MEMORANDUM

TO: District of Columbia Board of Zoning Adjustment
FROM: Arthur Jackson, Case Manager
 Joel Lawson, Associate Director Development Review
DATE: September 10, 2013
SUBJECT: BZA Case 18627 – Expedited review requested pursuant to § 3118 for special exception relief in accordance with § 223 for an addition to a one-family dwelling at 728 Whittier Street NW

Figure 2

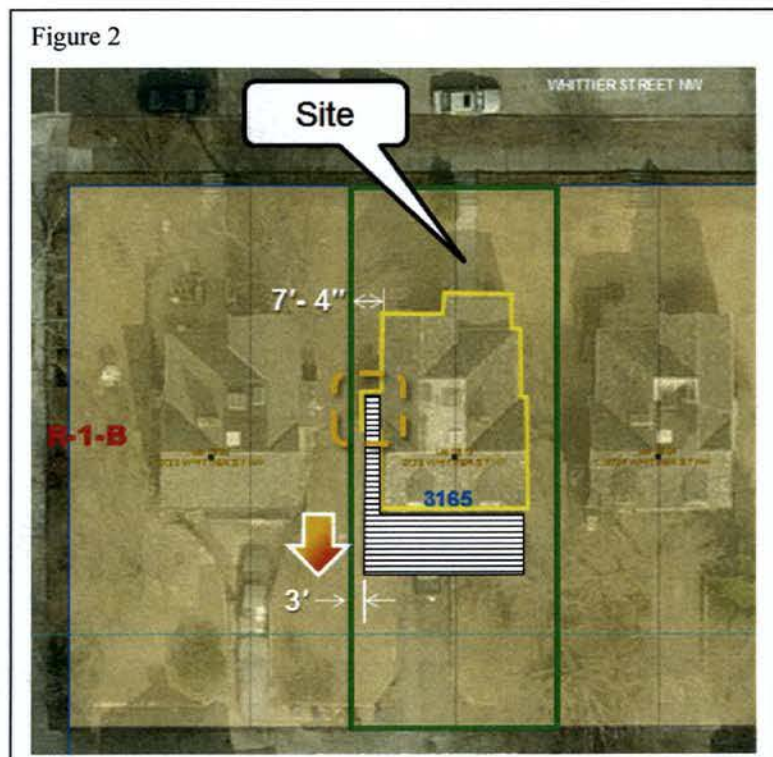
Based on the submitted annotated plat, the existing dwelling is set back 7' - 4" from the western property boundary. As a result of this proposal, the non-conforming side yard setback that currently exists would be extended further south. Section 2001.3 of the regulations state:

Although extending the non-conforming side yard further to the south would be inconsistent with the highlighted provision (refer to Figure 2), relief from § 2001.3 (b)(2) was not requested in the original application. OP shared this information with the applicant and the Zoning Administrator's Office.

The applicant subsequently submitted a supplement dated August 1, 2013 that: corrected the square and lot number of the subject property; and added special exception relief in accordance with § 223 from § 2001.3 (b)(2) to the original request. The OP analysis that follows reflects the amended application.
